Form 3160-5
(June 2019)UNITED STATES
DEPARTMENT OF THE INTERIOR
BUREAU OF LAND MANAGEMENTFORM APPROVED
OMB No. 1004-0137
Expires: October 31, 2021**SUNDRY NOTICES AND REPORTS ON WELLS**
Do not use this form for proposals to drill or to re-enter an abandoned well. Use Form 3160-3 (APD) for such proposals.5. Lease Serial No. **NMNM113898**

8. Well Name and No. **ONYX 35 FED COM/753H**9. API Well No. **30-025-51912**10. Field and Pool or Exploratory Area
HARDIN TANK, WOLFCAMP11. Country or Parish, State
LEA/NM**12. CHECK THE APPROPRIATE BOX(ES) TO INDICATE NATURE OF NOTICE, REPORT OR OTHER DATA**

Onyx 35 Fed Com 714H (FKA 753H) API #: 30-025-51912

EOG respectfully requests an amendment to our approved APD for this well to reflect the following changes:

Onyx 35 Fed Com #714H

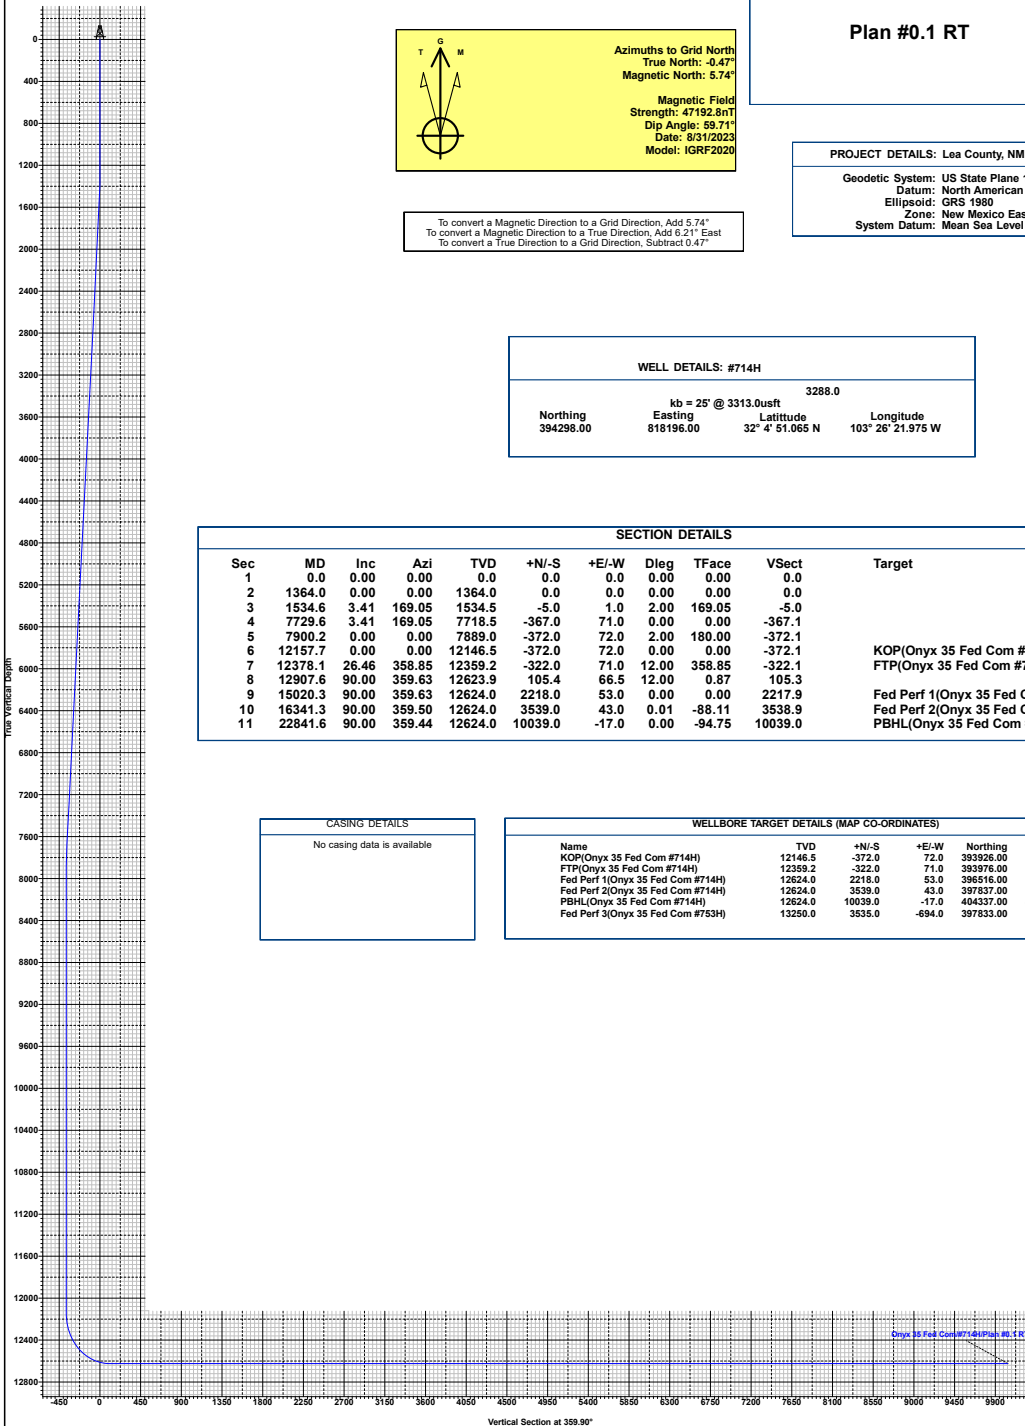
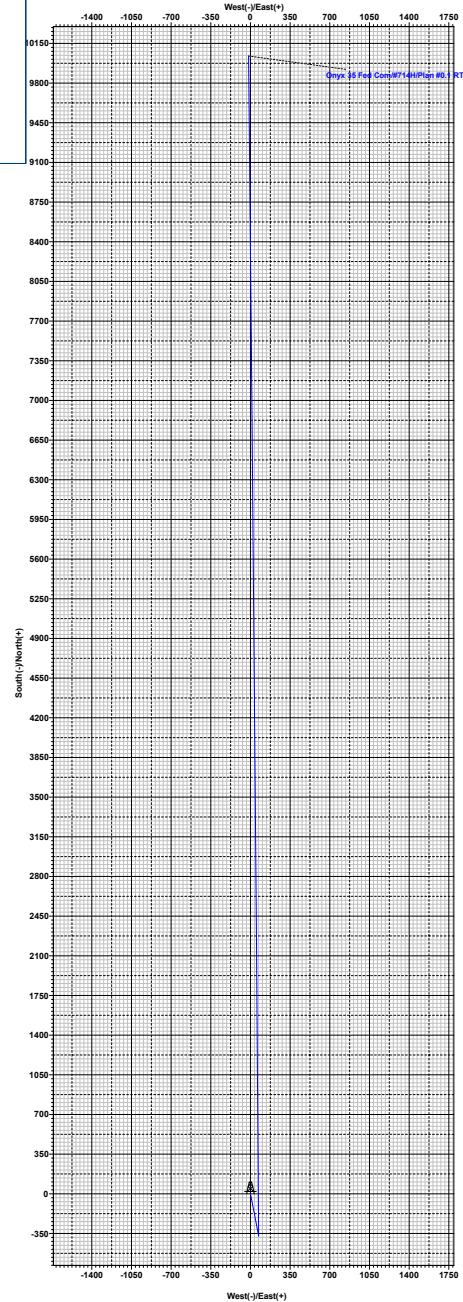
Change name from Onyx 35 Fed Com 753H to Onyx 35 Fed Com 714H.

Change BHL from T-25-S, R-34-E, Sec 26, 100' FNL, 2382' FWL, Lea Co., NM,
to T-25-S, R-34-E, Sec 26, 100' FNL, 2169' FEL, Lea Co., N.M.

Change target formation to Wolfcamp Clastics Y.
